POLICY ISSUE
(Commission Meeting)

SECY-89-114

REQUEST FOR COMMISSION APPROVAL FOR THE RESTART OF THE
PEACH BOTTOM ATOMIC POWER STATION

SAFETY EVALUATION REPORT
ON THE PHILADELPHIA ELECTRIC COMPANY'S PLAN
FOR RESTART OF THE PEACH BOTTOM ATOMIC POWER STATION

Figure 2.1 Corporate reporting structure for the nuclear organization

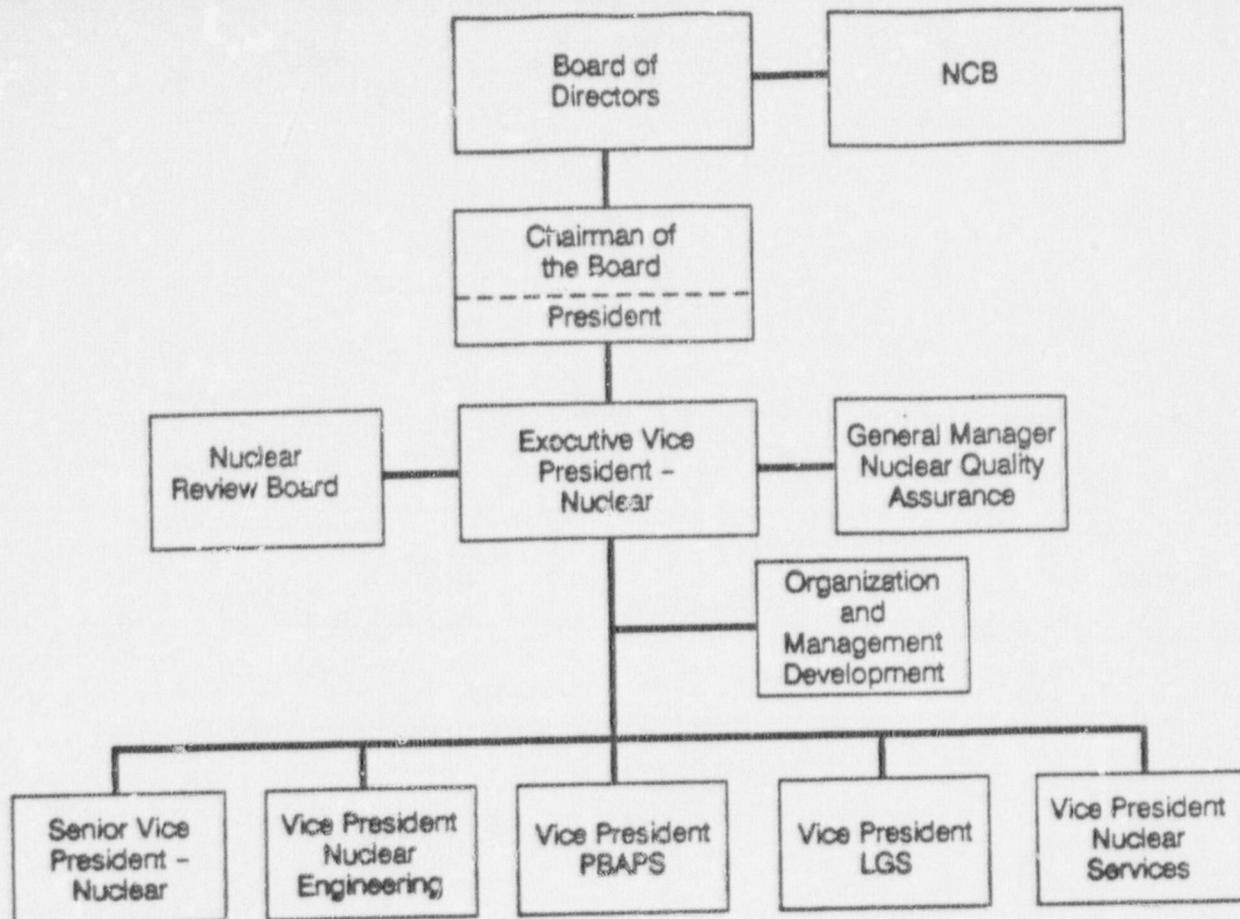
There are three staff organizations and five line organizations that report to the Executive Vice President-Nuclear, as shown in Figure 2.1. The five line organizations have responsibility for the Limerick Generating Station, Unit 2 construction, the corporate Nuclear Engineering and Nuclear Services groups, and the operating site groups at Peach Bottom and Limerick. The three licensee staff organizations have responsibility for the corporate Nuclear Review Board (NRB), Nuclear Quality Assurance (NQA), and Organization and Management Development.

Figure 2.3 Site organization

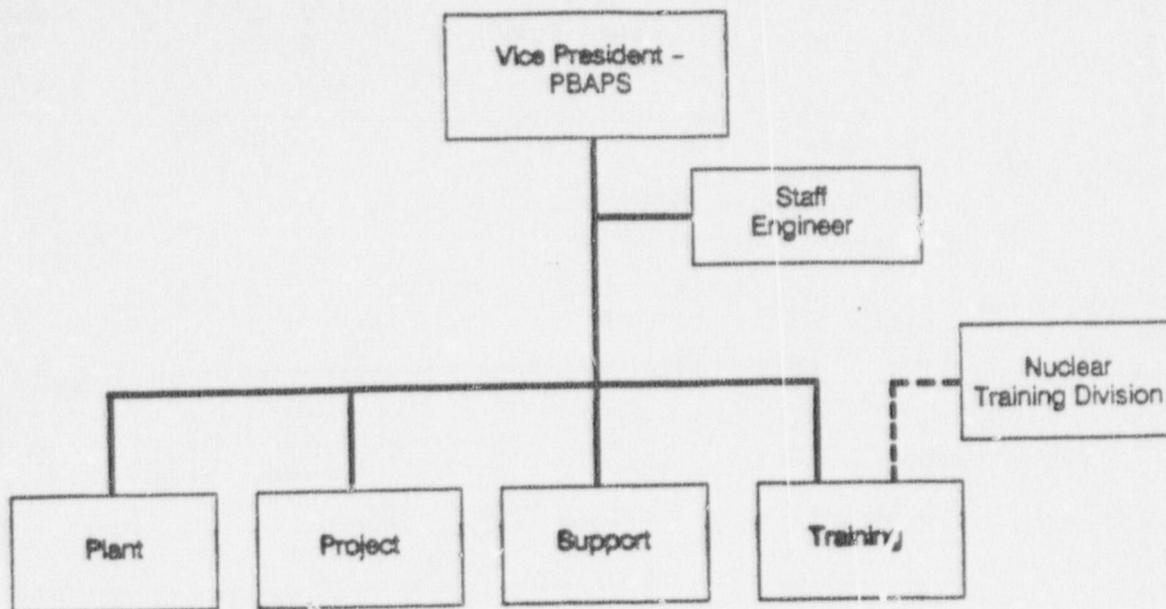
Figure 2.3 is a functional organization chart of the reorganized onsite management team with four positions reporting to the Vice President-PBAPS. The four positions are Plant Manager, Project Manager, Support Manager, and Training Superintendent. The staff reviewed the qualifications and training of PBAPS managers as given in Appendix B of the restart plan, with a special emphasis on the operations organization (see Section 4.1.2 of this SER), to ascertain that the qualification and experience of each meet the licensee's first objective to establish a Peach Bottom management team with strong leadership and management skills and satisfy the guidance of RG 1.8 and licensee commitments.

Figure 2.3 shows the top management reporting structure and division of functional responsibilities for the site organization. Figure 4.1, which shows the Plant Manager's organization, provides more information about the reporting structure and functional responsibility assignments at the superintendent level.

Figure 2.4 Nuclear engineering and nuclear services

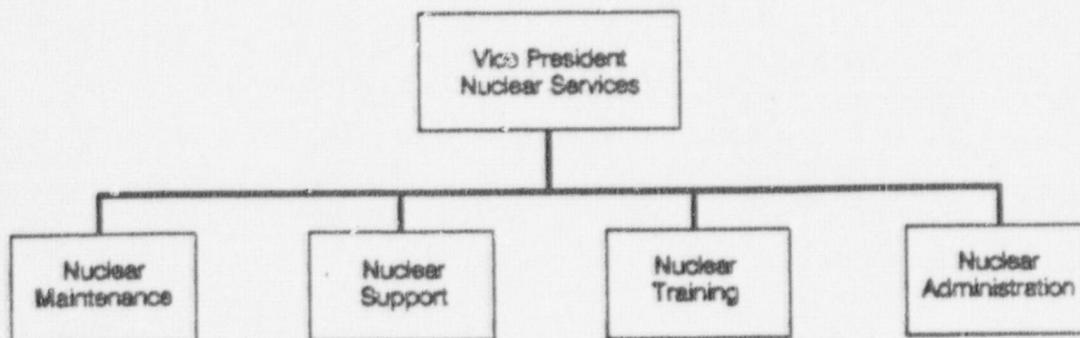
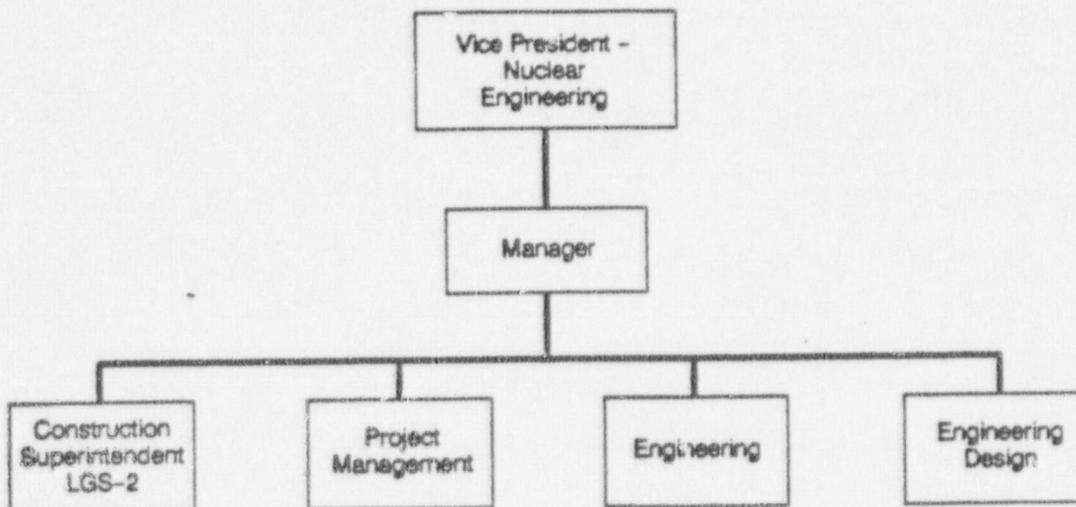
The Vice President-Nuclear Services is responsible for nuclear service activities that support both the Peach Bottom and Limerick stations. The Vice President-Nuclear Services, as shown in Figure 2.4, is responsible for the support, maintenance, training, and administration groups.

Figure 4.2 Shift operations management organization chart

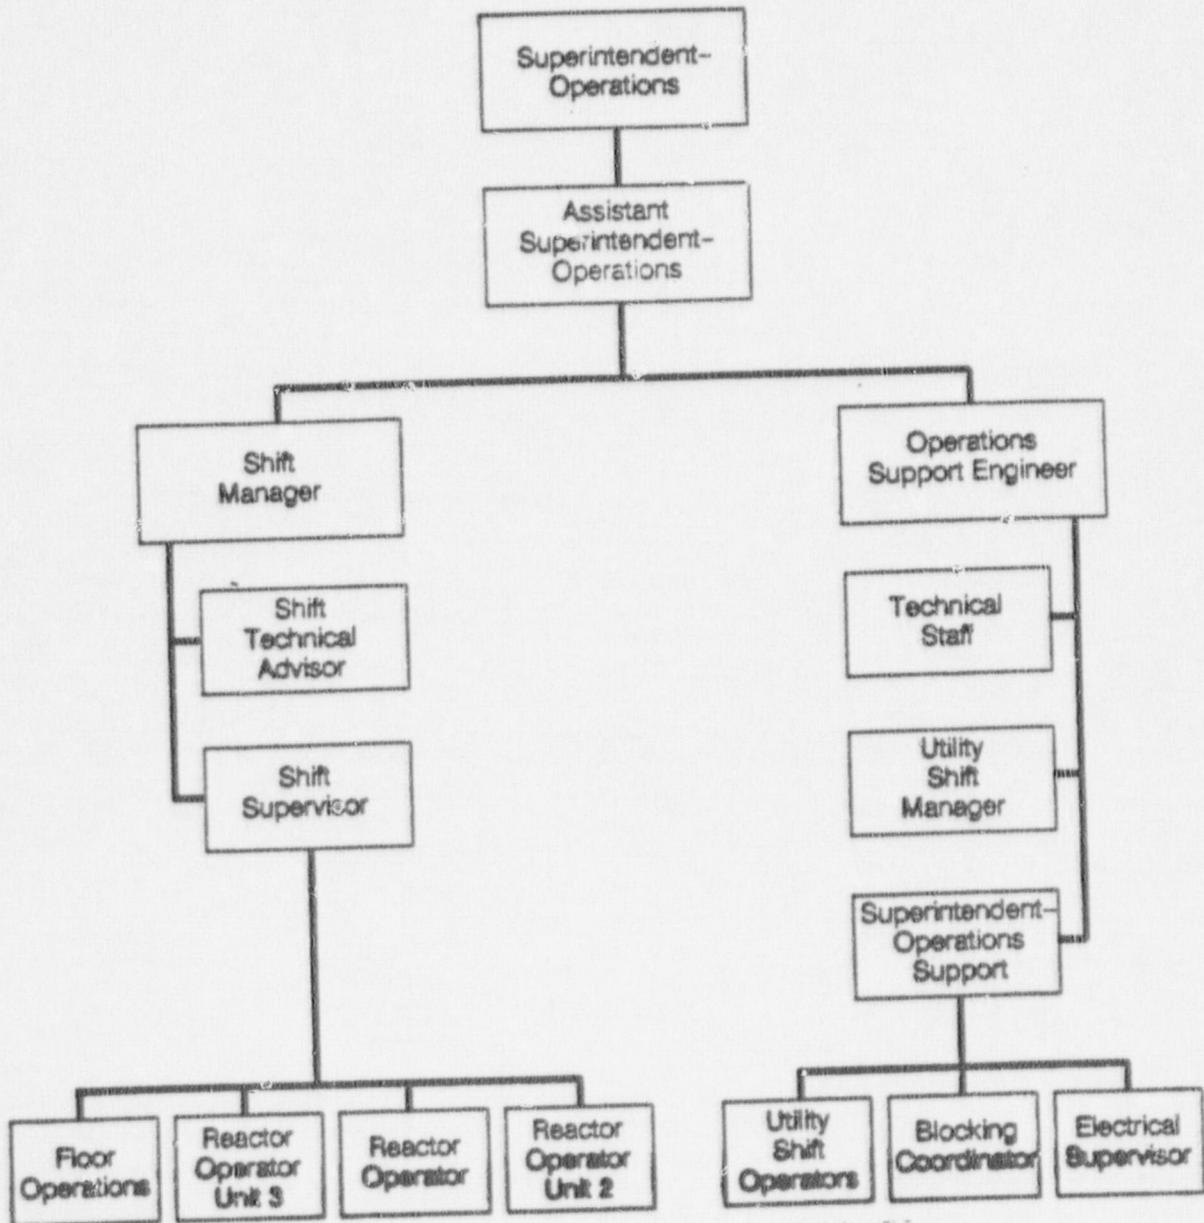
Figure 4.2 shows the management structure for shift operations. The licensee established and filled the new position of Assistant Superintendent-Operations to assist the Superintendent-Operations in day-to-day shift operations management and administration and to ensure that one of these two senior operations managers is routinely available to operations personnel on shift.
